Access Compliance Report

Public Rights-of-Way

(Curb Ramps)

Intersection ID: 49135	Main Street: AMBER_LEIGH_WAY_DR	Cross Street: AMESBURY_HILL_DR	Location: E
ADA ID: 3DC50A586C4A	Ramp Type: Perp	Initial Pass/Fail: Pass	Overall Compliance: No
Severity Score: 0			
Codes/Mitigation Info/Possible Solution		Field Measurements/Component Compliance

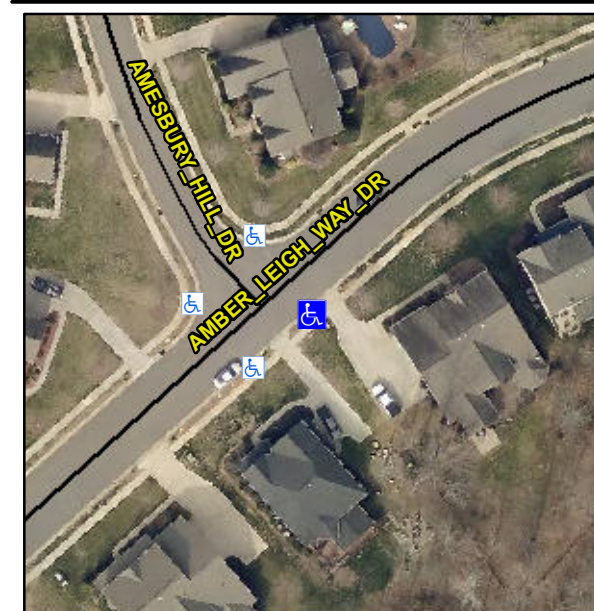
R304.2.1, R305.2

Compliance	Description	Data	Compliance	Description	Data
N/A	Ramp Length (in)	48.5	Yes	Ramp Slope (%)	6.0
Yes	Ramp Width (in)	48.0	Yes	Ramp XSlope (%)	1.1
N/A	Flare Type LT	Sloped	N/A	Flare Type RT	N/A
N/A	Flare Slope LT (%)	8.8	N/A	Flare Slope RT (%)	5.7
N/A	Flare Traversable LT?	Yes	N/A	Flare Traversable RT?	No
No	Landing Length (in)	47.0	Yes	DWS Provided?	Yes
Yes	Landing Width (in)	48.0	Yes	DWS Contrast?	Yes
Yes	Landing Slope (%)	1.3	Yes	DWS Length (in)	24.5
Yes	Landing X Slope (%)	1.3	Yes	DWS Full Width?	Yes
N/A	Landing Curb? (Y/N)	No	No	DWS Offset (in)	6.0
N/A	Shared Landing?	No			
Yes	Gutter Ponding?	No	Yes	Gutter Slope (%)	0.6
Yes	Gutter Lip Ht (in)	0.0	Yes	Gutter X Slope (%)	0.9
N/A	Painted X Walk1?	No	N/A	Painted X Walk2?	N/A
	X Walk 1 Direction	To NW		X Walk 2 Direction	N/A
N/A	X Walk 1 Width (in)	N/A	N/A	X Walk 2 Width (in)	N/A
	X Walk 1 Slope (%)	2.8		X Walk 2 Slope (%)	N/A
	X Walk 1 X Slope (%)	1.2		X Walk 2 X Slope (%)	N/A

N/A	Ramp inside XWalk1?	N/A	N/A	Ramp inside XWalk2?	N/A
	Road Slope (%)	N/A	N/A	Clear Space?	Yes
	Road X Slope (%)	N/A	N/A	Clear Space to XWalk (in)	N/A
Yes	Any Obstructions?	No	Yes	Storm Grate/Utility Hazard?	No
	Obstruction Type			Storm Grate/Utility Type	
		N/A			N/A
			Yes	Surface Condition? (G/P)	Good

Remove & Replace Entire Ramp.
